# UNITED STATES PATENT AND TRADEMARK OFFICE

APPLICATION NO.	FILING DATE	FIRST NAMED INVENTOR	ATTORNEY DOCKET NO.	CONFIRMATION NO.
10/083,764	02/25/2002	Pia C. Licciardi	4364-4000	7512

## Office Action Summary

## **DETAILED ACTION**

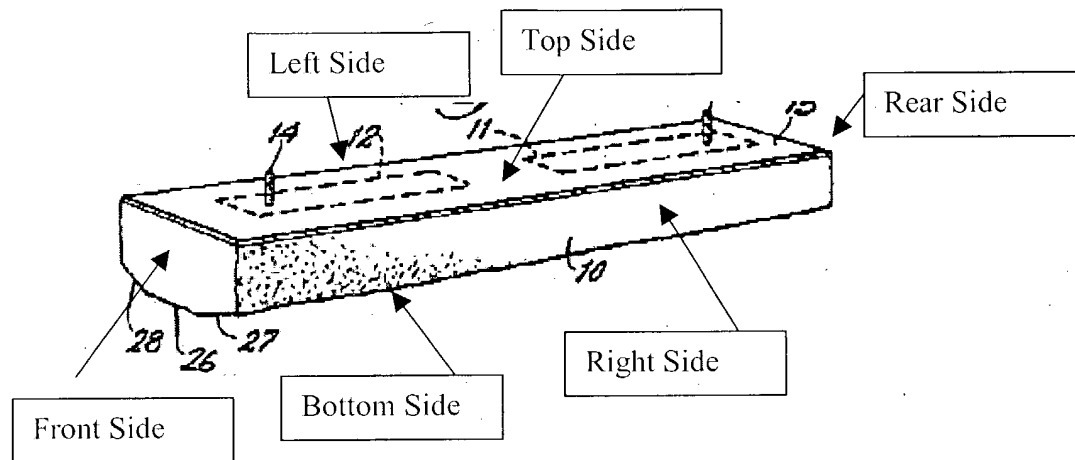
Rebernak teaches a mop head comprising a top surface, a bottom surface and two side surfaces (see figure below). The top surface adjoins the right and left side surfaces at an edge. The edge extends from the front surface to the rear surface. The side surfaces have a sculpted cutout (27, 28, figure 2) that will correspond to the shape of quarter round molding when placed in contact. A support member (16) is attached to the top surface of the mop head and a handle

(20) is attached to the support member. The side surfaces of the mop head extend beyond the side surfaces of the support member (figure 1).

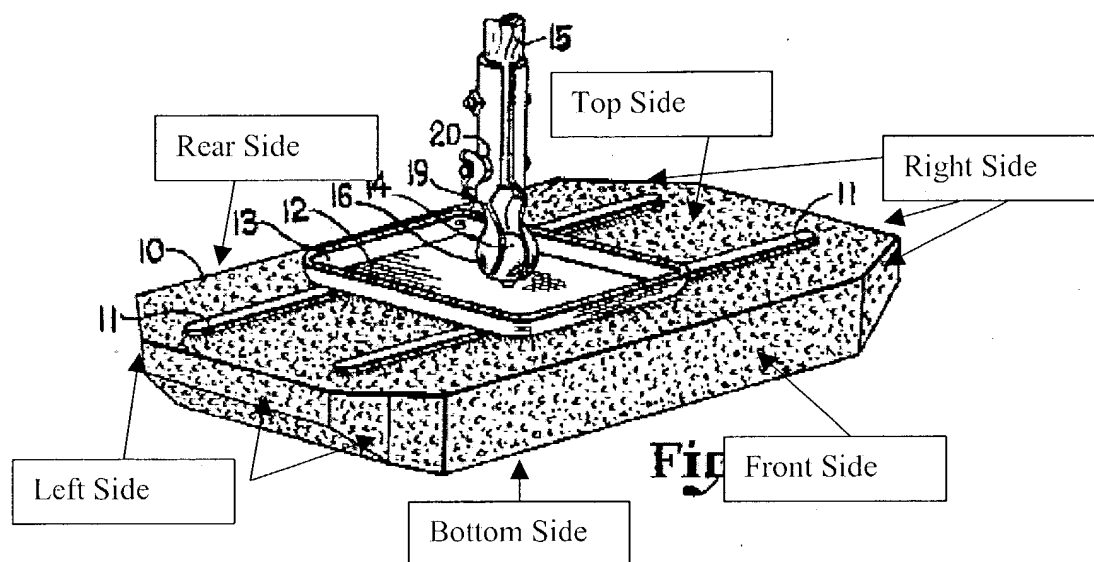
Wheeler teaches an octagonal mop head comprising a top surface, a bottom surface and two side surfaces (see figure below). The top surface adjoins the right and left side surfaces at an edge. The edge extends from the front surface to the rear surface. The side surfaces have a sculpted cutout (col. 2, lines 18-21 and figures 1 and 2) that will correspond to the shape of a quarter round molding when placed in contact. A support member (12) is attached to the top surface of the mop head and a handle (15) is attached to the support member. The side surfaces of the mop head extend beyond the side surfaces of the support member (figure 1).

As for Wheeler, the mop is an octagon shape and therefore each side surfaces actually comprises three sides. The corners that are cut off are not part of the indentation but part of the actual shape of the mop head. The indentations occur only on the side surfaces and the bottom surface. This being the case, it is clear from figure 1 that the indentations do have a uniform cross section.
